Job: TH - Walled Garden Buildings

Title: Door Details - DTB7 P2
Door Type - B7
Sheet 1 of 3

Type: Building 16 & 16a

Status: FOR PLANNING

03 Door Type B7 - Timber Framed and Battened Entrance Door Internal Elevation
761.1 SCALE 1:10 @ A1

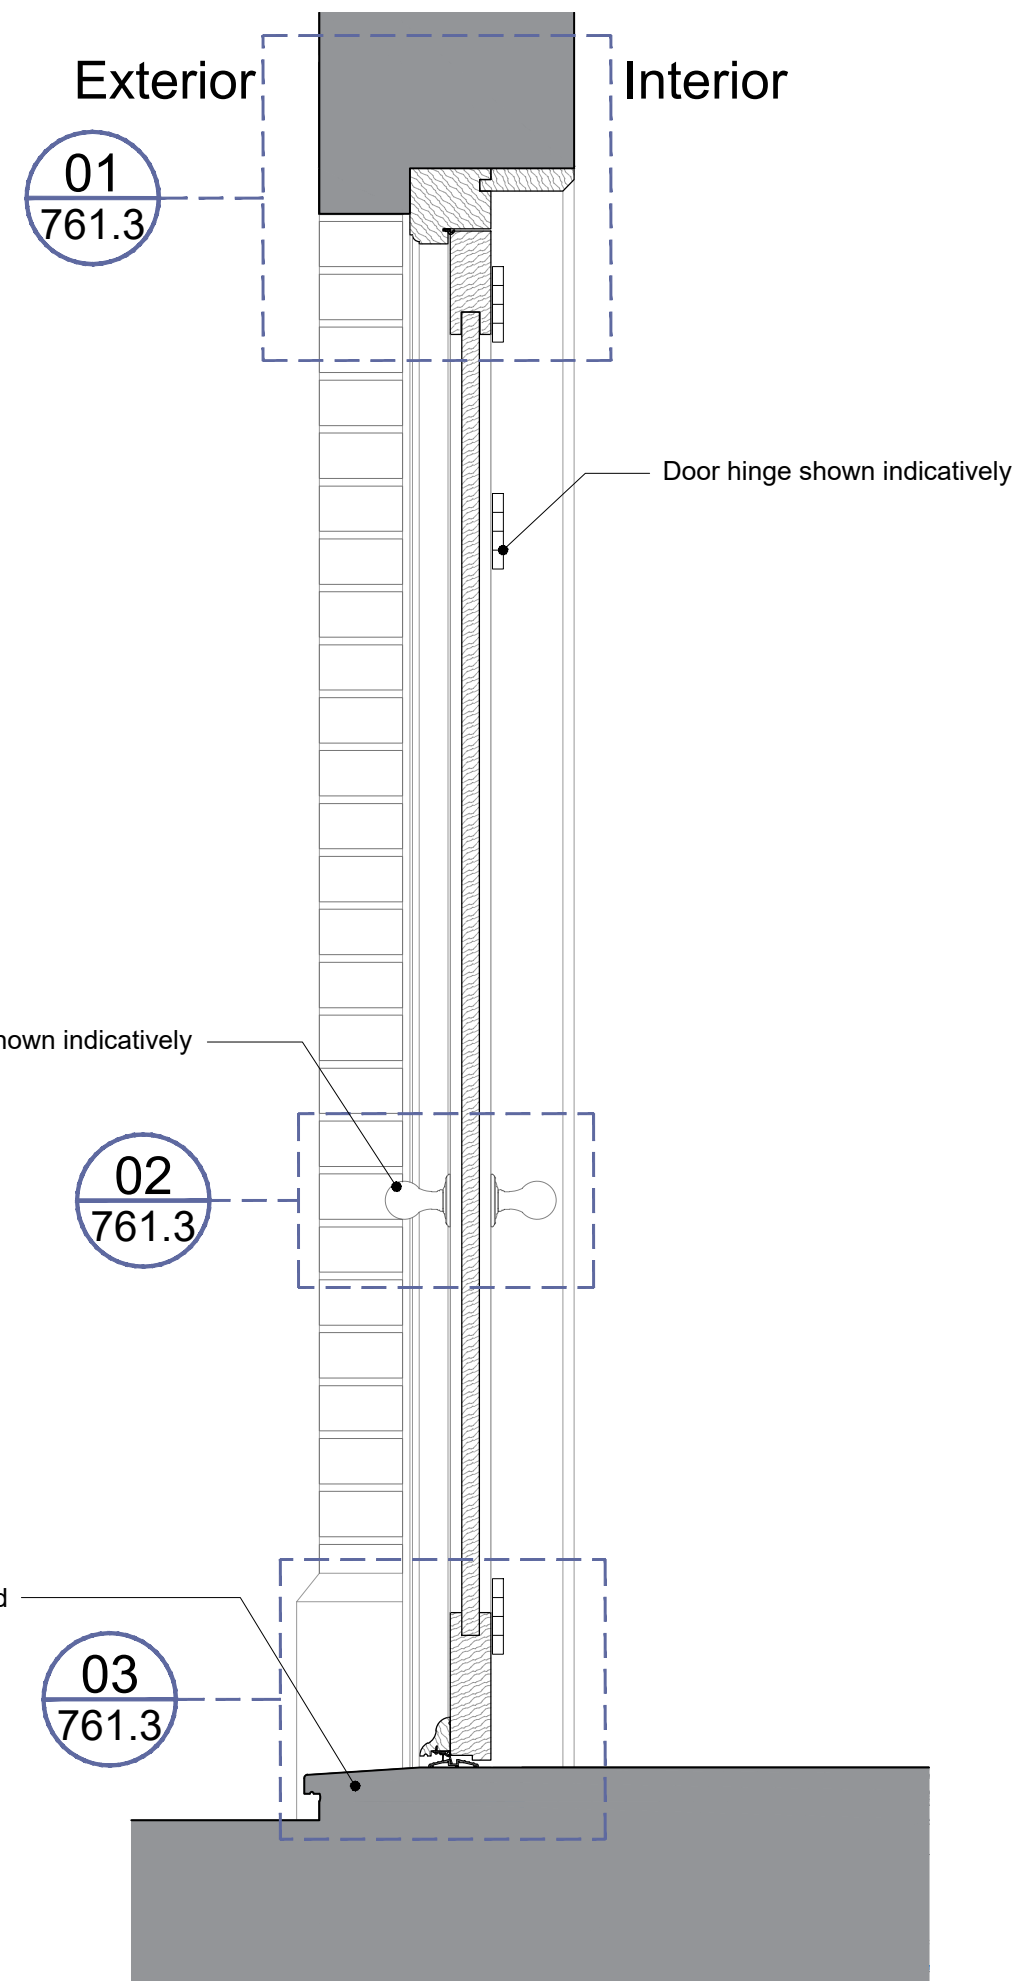
P2	Door amended to traditional timber frame and battened door with beaded detail following officers' comments. Details titles updated.	07/04/26
P1	Initial Release	dd/mm/yy
no.	revision.	date.
